Preliminary Adequacy PR12

Re: Trapper Mine Inc; Permit C1981010
DRMS Preliminary Adequacy Review of Permit Revision No. 12 (PR12)

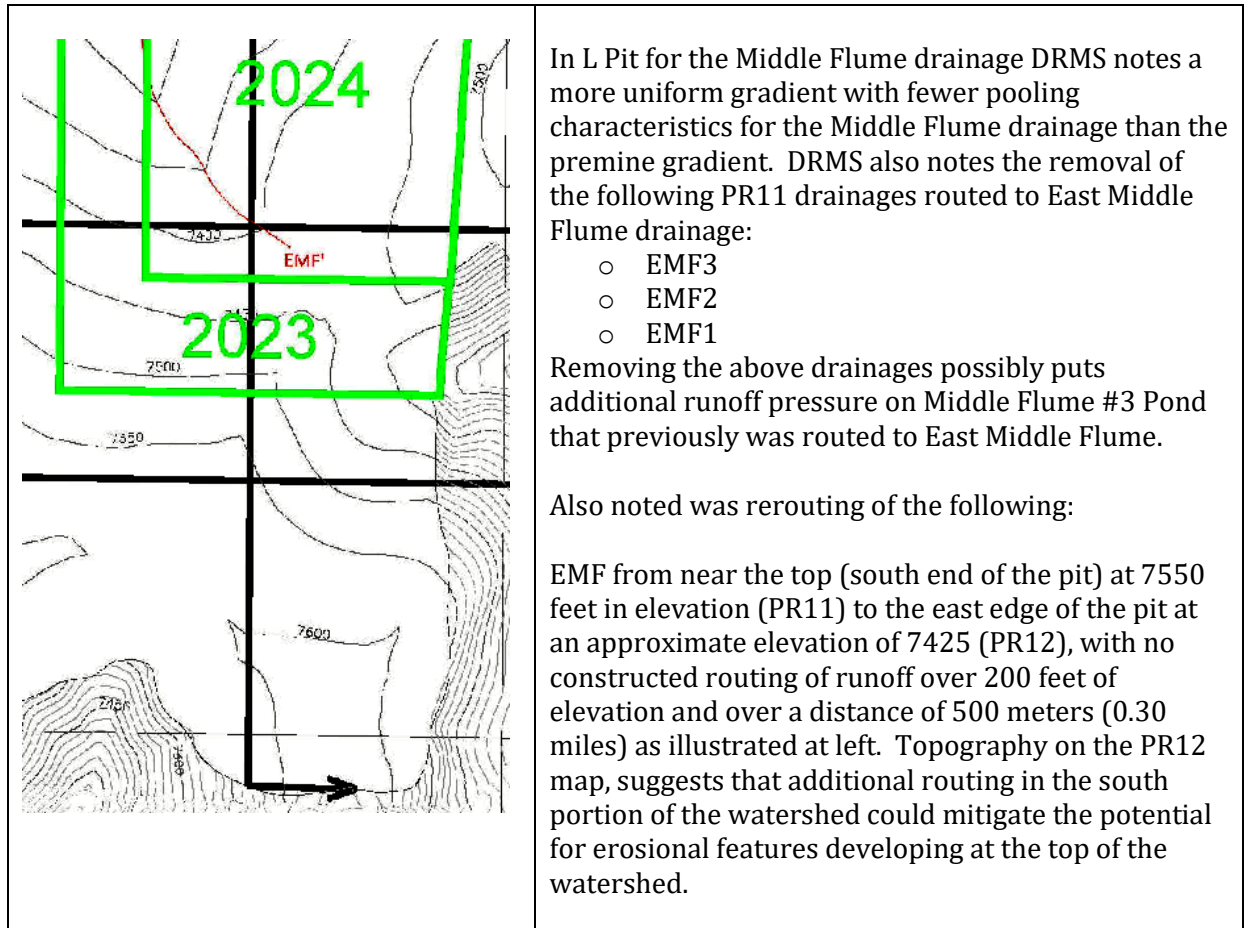
For the N Pit DRMS notes additional constructed drainages added at the east end of the pit and drainage expansions along the south edge of the pit. The drainages transmit runoff to the East Pyeatt System. The drainage profile submitted with the application indicates that the East Pyeatt

post mining drainage flows overall at a deeper/lower elevation than premining. Please indicate what situation the lower elevation profile addresses.

2. *To what extend is there possibly a shortage of fill for the slopes?*

3. *Please discuss Trappers rational for not constructing routing at the upper section of the subwatershed.*
